HEARING DATE: July 18, 2024
Continued from: December 7, 2023; February 15, 2024; April 4, 2024; May 16, 2024; and June 20, 2024

TO: Planning & Zoning Commission

SUBJECT: Blayden Subdivision – AZ, PP, CUP
[H-2023-0043](#)

LOCATION: South side of W. Chinden Blvd. and west side of N. Black Cat Rd. in the NE 1/4 of Section 28, T.4N., R.1W.

FIGURE 3D: MIXED USE REGIONAL CONCEPT DIAGRAM

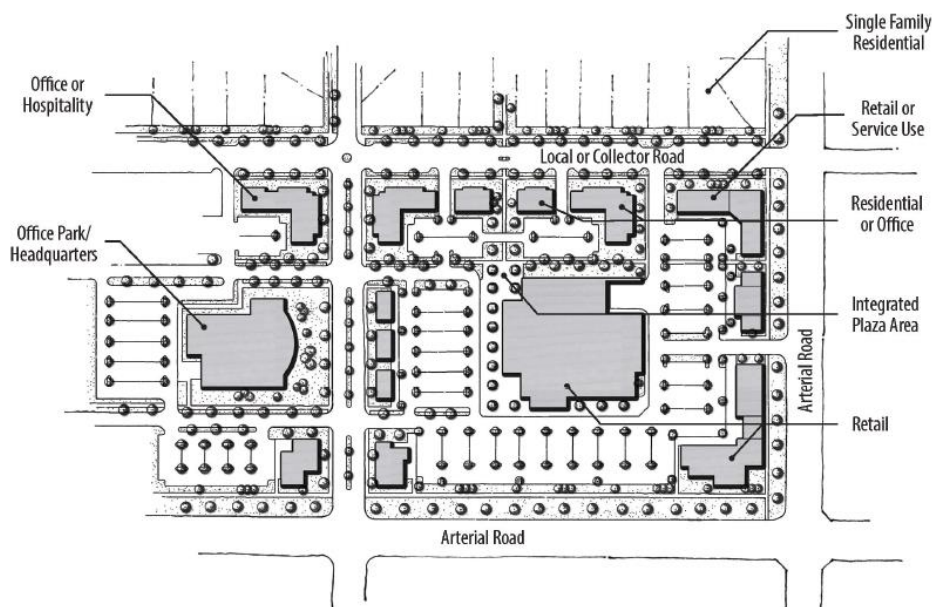
Although the proposed development plan incorporates the mix of uses desired in MU-R areas, the site isn't designed in accord with the concept diagram shown above. Multi-family residential and some office uses (instead of retail or service uses) are proposed directly adjacent to US 20-26 and Black Cat Rd., both arterial streets, rather than off a local or collector road. The mid-box retail building is planned in back of the office park away from the arterial street (Black Cat) off the collector street (Ramblin) and across the street from planned single-family residential uses – if the mid-box retail building and office uses switched spots it would create better visibility for the retail use and a better transition in uses if office were provided next to single-family residential uses – at a *minimum*, Staff recommends this change to the plans. Lastly, Staff recommends the plaza area planned along the south side of the collector street in the holding area is relocated to the south to better integrate with the commercial/office park and to be more accessible for the users in that area. Overall, it's Staff's opinion the uses are “swapped” from what they should be per the concept diagram above.

Staff discussed with the Applicant during the initial pre-application meetings relocating the residential uses to the south and west away from Chinden & Black Cat with commercial uses along these transportation corridors instead, consistent with the MU-R concept diagram above and for better air quality for residents; however, the Applicant declined to do so. Staff acknowledges some of the difficulties in doing so include the configuration of the site, the location of the collector street through the site, and not having control of the land at the northeast corner of the development area. **The City Council should determine if it's in the best interest of the City to approve annexation of the property at this time with the proposed development plan or request a re-design to be more consistent with the MU-R concept diagram above.**

MERIDIAN, ID PRELIMINARY PLAT LANDSCAPE PLAN

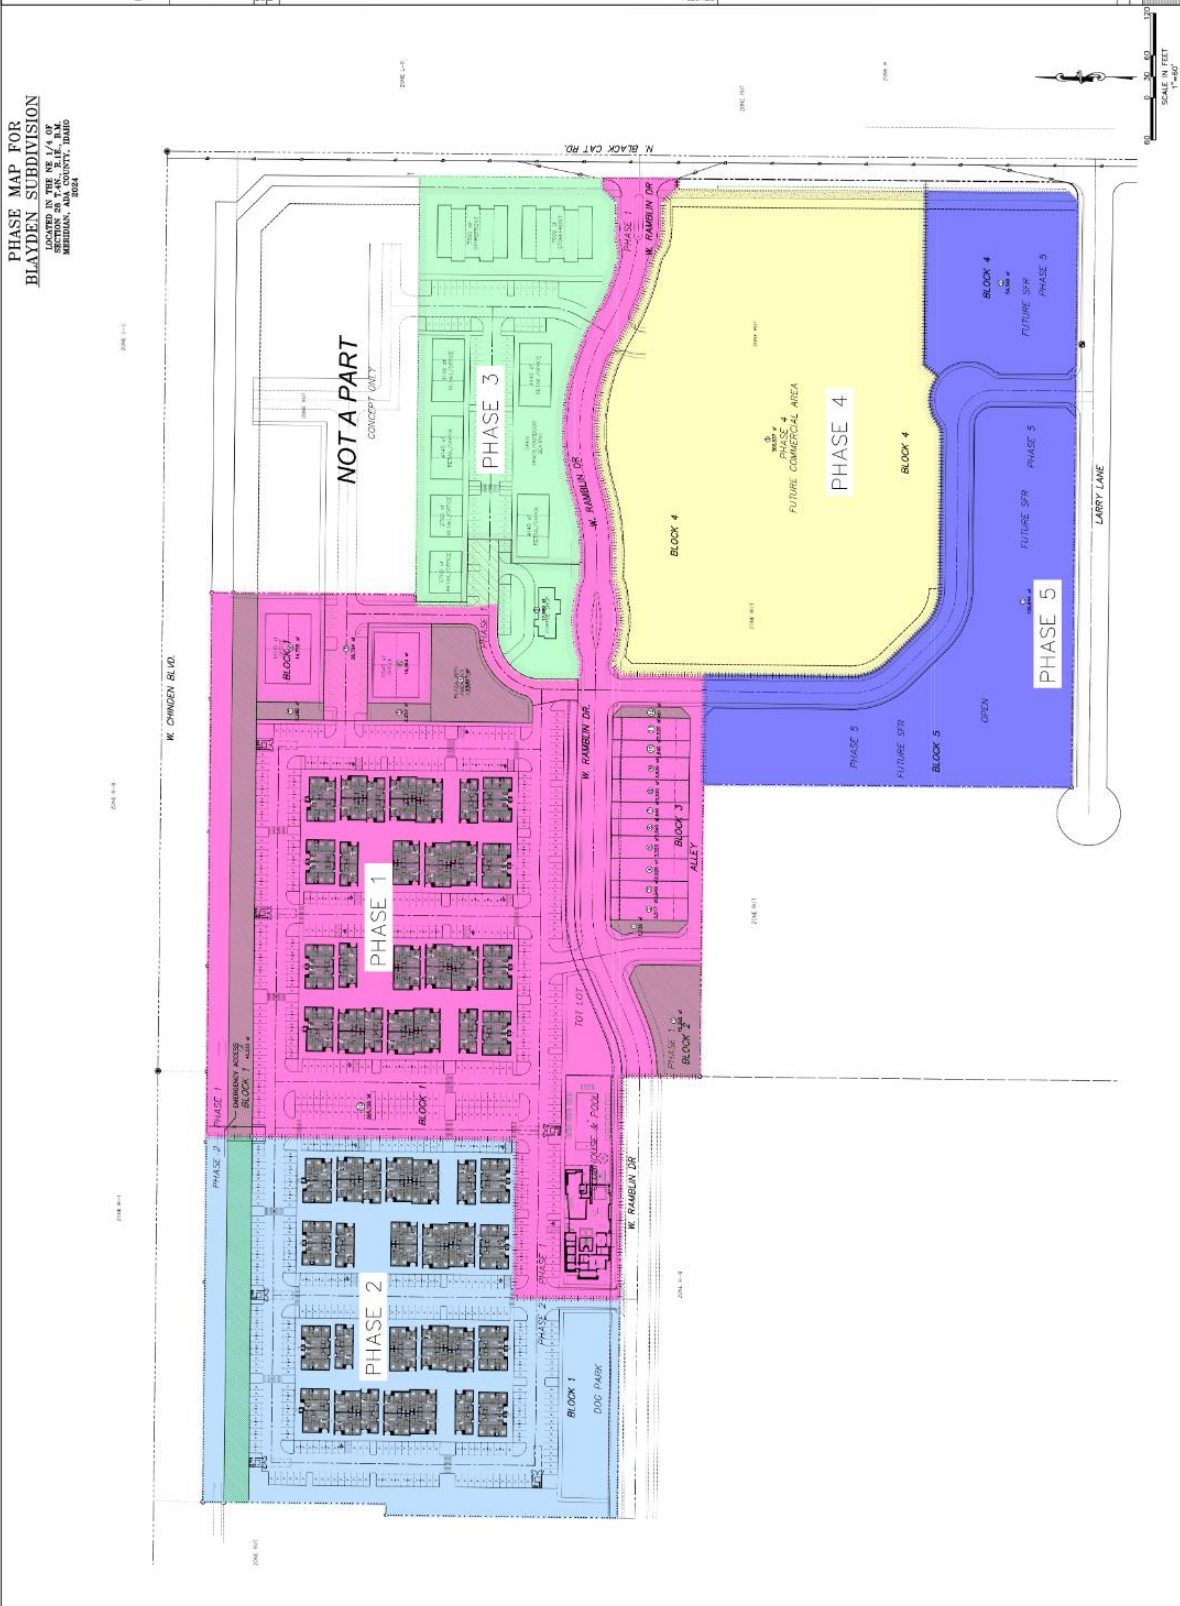
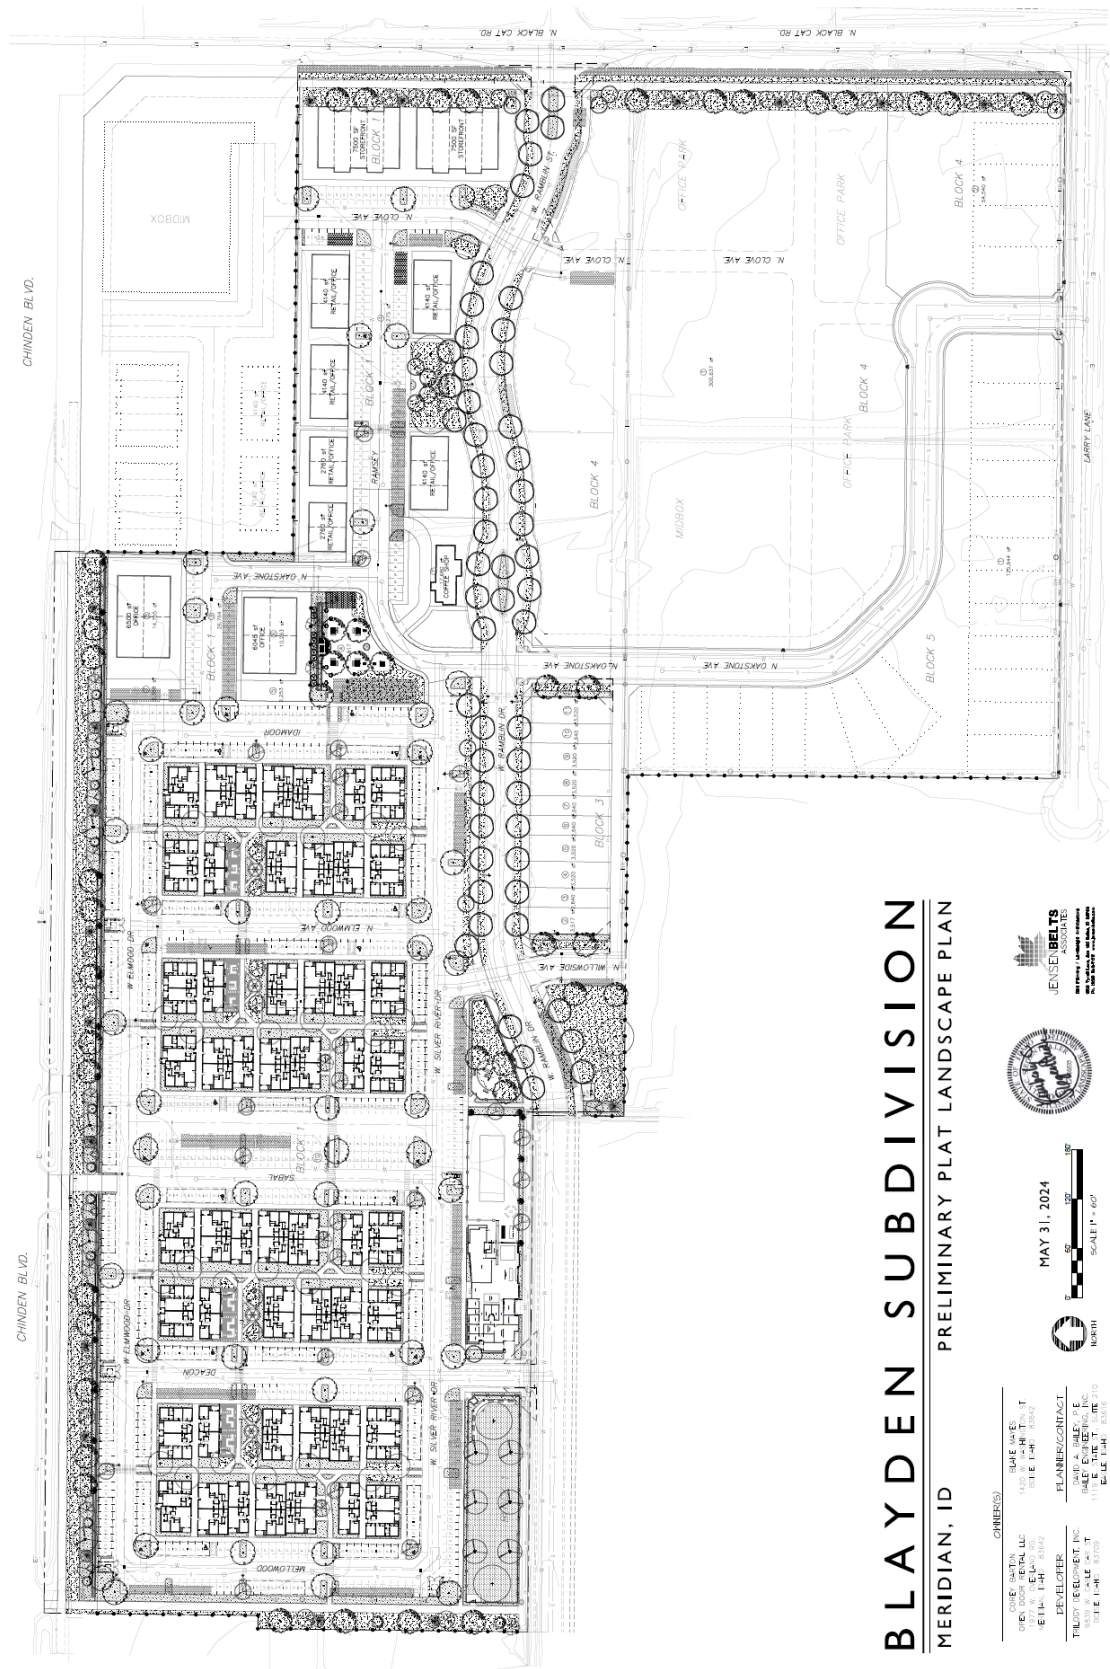
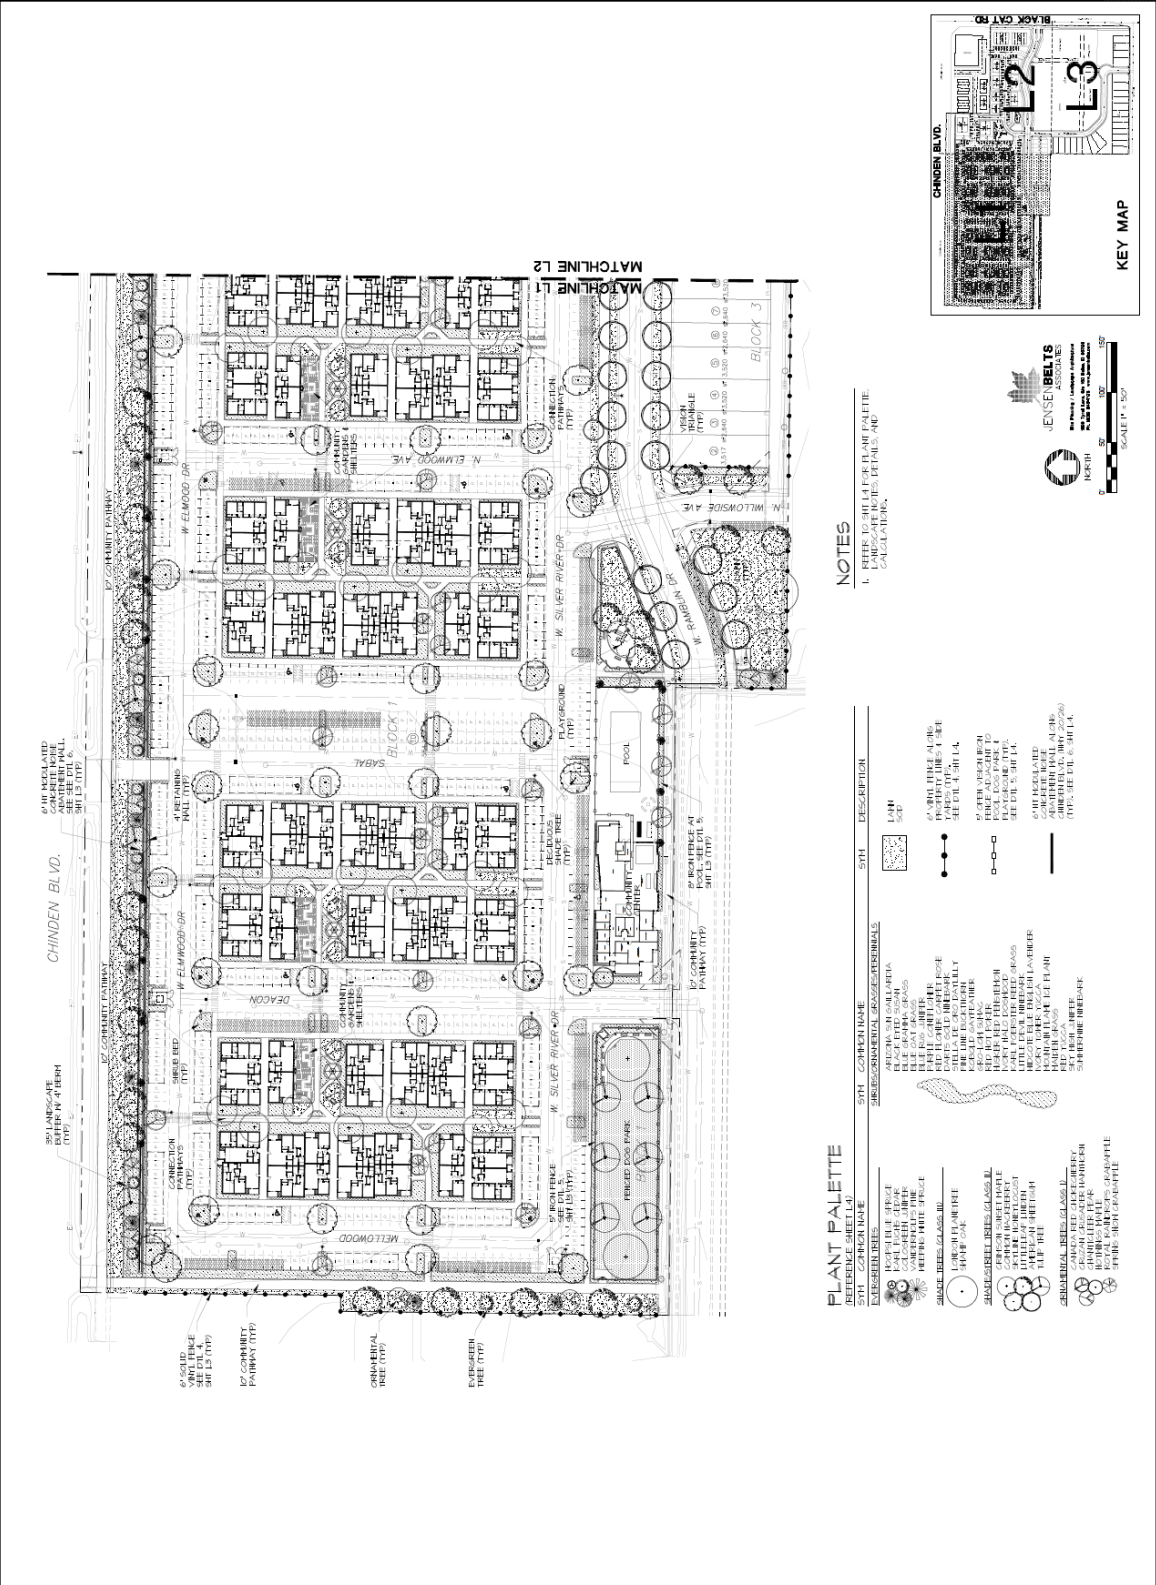
Landscaping: A 35-foot wide street buffer is required along W. Chinden Blvd./SH 20-26 and N. Black Cat Rd., both entryway corridors; and a 20-foot wide street buffer is required along W. Ramblin Dr., a collector street, measured from *ultimate* back of curb location. **Landscaping is required within the street buffers in accord with the standards listed in UDC [11-3B-7C](#); enhanced landscape design features are required along entryway corridors – revise plan accordingly. If the unimproved right-of-way (ROW) is 10' or greater from the edge of pavement to edge of sidewalk or property line, the developer is required to maintain a 10' wide compacted gravel shoulder meeting the construction standards of the transportation authority and landscape the remainder with lawn or other vegetative groundcover as set forth in UDC 11-3B-7C.5; revise the plan accordingly and depict the location of the edge of pavement.**

Noise abatement is required for residential uses adjoining state highways consisting of a berm or a berm and wall combination parallel to the state highway in accord with the standards listed in UDC [11-3H-4D](#). The Applicant proposes a 4-foot tall berm with a concrete retaining wall on the south side of the berm and a 6-foot tall concrete modulated wall on top of the berm along Chinden Blvd. **A detail should be submitted with the final plat application that includes the centerline location/elevation of Chinden Blvd. in relation to the berm and wall, and other applicable information that demonstrates compliance with the required standards. The landscape plan depicts a break in the wall midway through the multi-family development where an emergency access is proposed; breaks in the berm/wall will degrade the function and are not allowed – the emergency access should be moved to the west boundary of the site.**

Landscaping, including trees and bushes, is required along all pathways in accord with the standards listed in UDC [11-3B-12C](#) and should be depicted on the landscape plan submitted with the final plat application. Minimum 5-foot wide landscape strips are required to be provided along each side of the pathway; designs are encouraged in which the width of the landscape strip varies to provide additional width to plant trees farther from the pathway to prevent root damage (see UDC 11-3B-12C for more information).

There are several existing trees on the site – where possible, existing trees should be retained. Mitigation is required in accord with the standards listed in UDC [11-3B-10C.5](#); calculations demonstrating compliance with the aforementioned standards should be depicted on the landscape plan submitted with the final plat.

Landscaping is required to be provided along all pathways per the standards listed in UDC 11-3B-12C, which require a mix of trees, shrubs, lawn, and/or other vegetative groundcover within 5-foot wide strips on each side of the pathway; the landscape plan should be revised accordingly.

- b. Include a detail/cross-section of the berm and wall within the street buffer along W. Chinden Blvd. that demonstrates compliance with the noise abatement standards in UDC [11-3H-4D](#). Include the elevation of the centerline of W. Chinden Blvd. in relation to the top of the wall and the method of variation in the wall (i.e. color and/or texture or staggered every 300'). Breaks in the berm/wall are not allowed.

- f. Include a detail for the area where the emergency access driveway is proposed that shows how the area will be improved with a berm/wall, landscaping and pathway once the driveway is removed.

- g. Depict the edge of pavement on the plan. If the unimproved street right-of-way along W. Chinden Blvd./SH 20-26 is 10-feet or greater from the edge of pavement to edge of sidewalk or property line, depict a 10-foot wide compacted shoulder meeting the construction standards of the transportation authority and landscape the remainder with lawn or other vegetative ground cover in accord with UDC [11-3B-7C.5](#).

13. The landscape plan shall be revised as follows:
 - a. Depict landscaping along the foundations of all street facing elevations per the standards set forth in UDC [11-4-3-27E.2](#).

- b. Depict landscaping along all pathways per the standards listed in UDC [11-3B-12C](#).
14. A legally binding document shall be recorded that states the maintenance and ownership responsibilities for the management of the development, including, but not limited to, structures, parking, common areas, and other development features as set forth in UDC [11-4-3-27F](#). A copy of such shall be submitted to the Planning Division prior to issuance of the first Certificate of Occupancy within the development.

D. Conceptual Development Plan for Holding Area

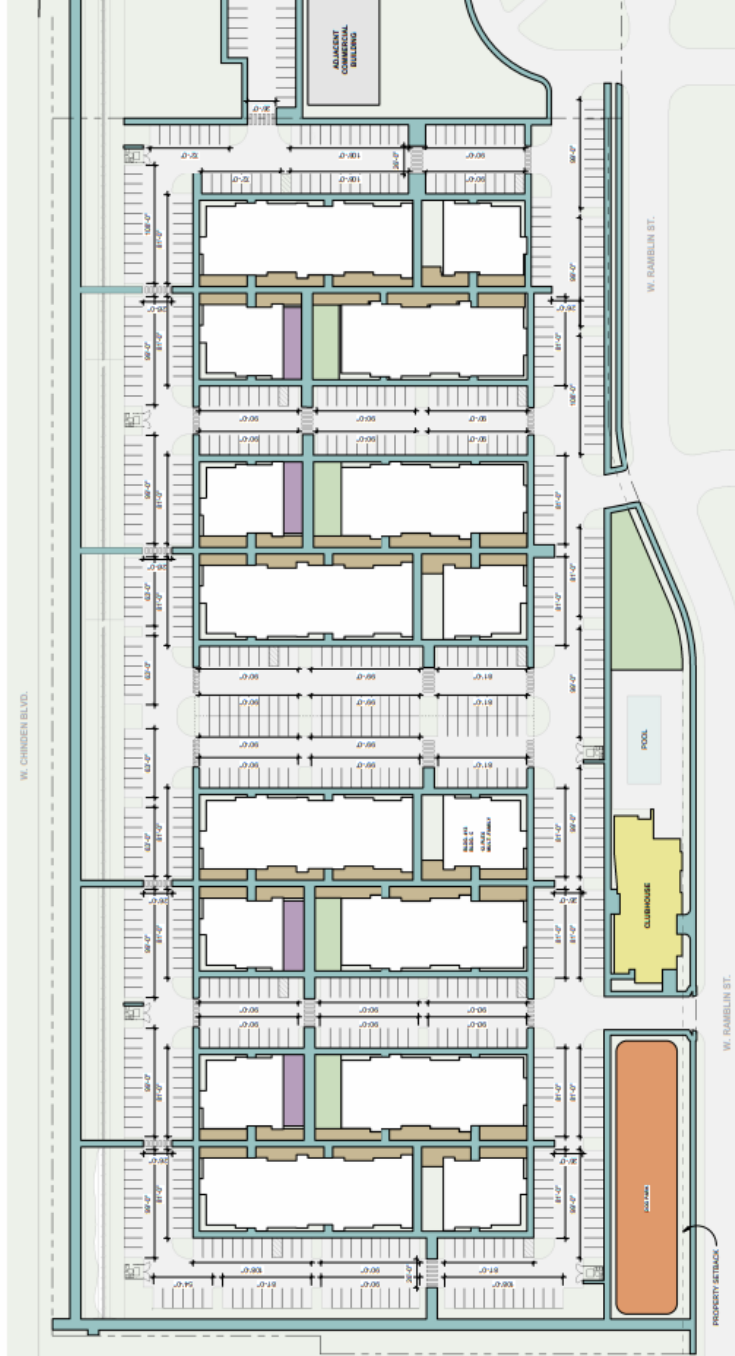
- f. The density of the single-family residential area depicted on the conceptual development plan for the holding area in Section VII.D shall develop with a gross density between 3 and 8 units/acre consistent with the Medium Density Residential Future Land Use Map designation in the Comprehensive Plan.

- j. Prior to any development occurring in the holding area south of W. Ramblin Dr., an amendment shall be required to the Development Agreement to include an updated conceptual development plan and building elevations for that area that demonstrate consistency with the Comprehensive Plan and Unified Development Code.
